APPLICATION NO.	FILING DATE	FIRST NAMED INVENTOR	ATTORNEY DOCKET NO.	CONFIRMATION NO.
09/752,344	12/29/2000	Jan Suumaki	460-009995-US(PAR)	8635

Office Action Summary

DETAILED ACTION

Fig. 1

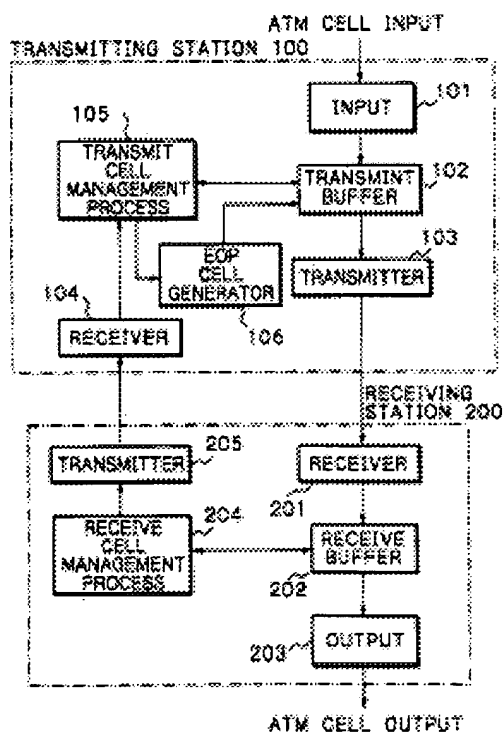
As per Claims 1, 11-12, Umeuchi et al. depicts, e.g., in Fig. 1 and related description in col. 3 line 40 et seq., the claimed method for making data transmission in a telecommunication network more effective, which comprises layer structure protocol means for data transmission, which protocol means comprise at least an upper layer and a lower layer, wherein the purpose of the lower layer (col. 3 line 45) is at least to compose a data unit (col. 3 line 44) to be transmitted to the upper layer (col. 3 line 45) from one or more segments (col. 3 line 43, col. 12 lines 45-48 & Fig. 8), in which method one or more errors (col. 3 line 50) occurring in the received segments (col. 3 line 50) is detected wherein said data unit to be transmitted to the upper layer

(e.g., col. 6 line 15 et seq.) is composed from one or more segments which contain one or more errors (col. 3 line 50), wherein information on the location of one or more errors (col. 3 line 50, col. 3 line 43, col. 12 lines 45-48 & Fig. 8) is also transmitted to the upper layer.

As per Claim 2, Umeuchi et al. depicts, e.g., in Fig. 1 and related description in col. 3 line 40 et seq., the claimed method in which it is also detected that an entire data unit (col. 3 line 50, col. 3 line 43, col. 12 lines 45-48 & Fig. 8) to be received is missing (col. 3 line 50, col. 3 line 43, col. 12 lines 45-48 & Fig. 8) characterized in that the location of the segment (col. 3 line 50, col. 3 line 43, col. 12 lines 45-48 & Fig. 8) of said missing data unit (col. 3 line 52: lost or missing) in the data unit (6) to be composed is interpreted as an erroneous area (col. 3 line 50, col. 3 line 43, col. 12 lines 45-48 & Fig. 8).
